From:
Sent: 02 January 2024 12:13
To: DCAdmin
Subject: Objection to planning reference 2023/93556

Comments on behalf of the Occupant of 135 Upper Batley Lane, WF17 0QT
a Retired Chartered Structural Engineer.

DRG NO. 135/1

Comments on Planning Ref. 2023/93556

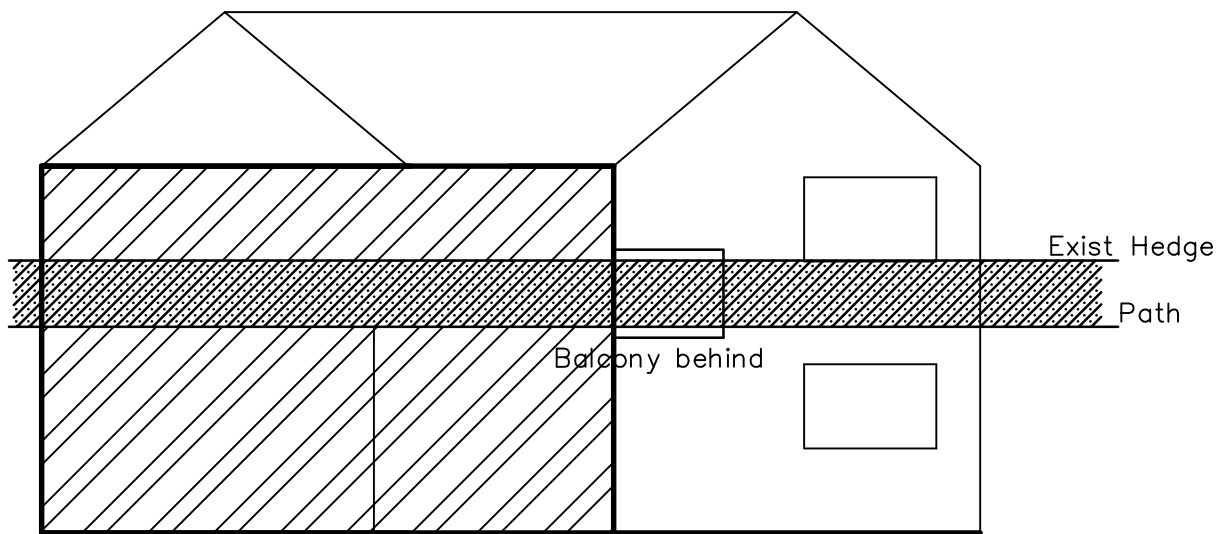
The ground levels indicated on the plans are shown at a the ground floor level of no. 216 which seems to indicated the gardens levels will be changed. This may have a detrimental effect on the whole of my boundary wall and I have asked a relative to look at it.

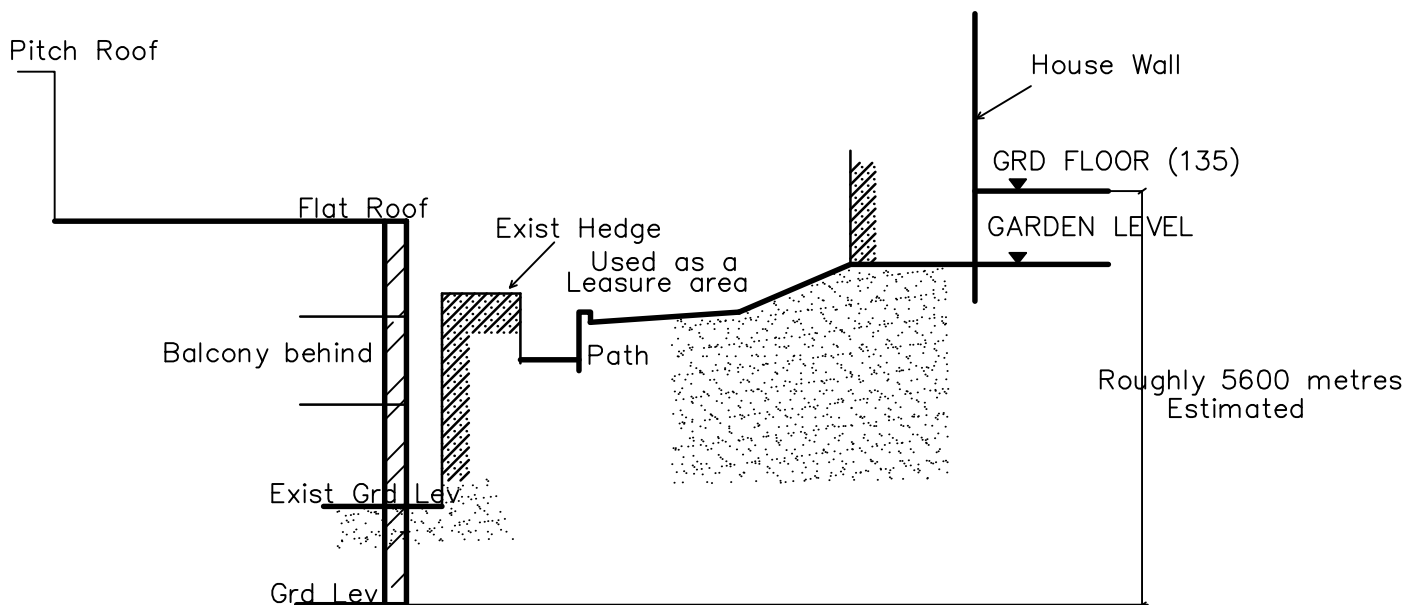
No levels are shown and it is not possible to determine exactly the cross section at the boundary. However an assessment has been made on the attached drg no. 135/1 using dimensions taken at the upper level and dropping a plumb line over the edge.

It is apparent from the new ground profiles shown on drg. nos. 23-110-p-02 & 03 that the ground levels are shown to suit the ground floor of the lower building. They are also a lot lower than the levels at the existing boundary and could undermine and disturb the ground in that area.

The difference in ground floor levels between the two houses appears to be about 5.60 metres and any construction at the boundary by reducing levels or excavating foundations without due consideration could undermine the area to some of the houses on Upper Batley Lane..

In my view if the ground profiles and the extension at the rear were reconstructed as indicated on the drawings a proper retaining wall will be required to be built by the applicant bearing in mind the soil and drainage conditions and a builder must ensure that the stability is maintained at all times. This wall should be properly designed by a qualified Structural Engineer to well known structural principles who should supervise its construction.
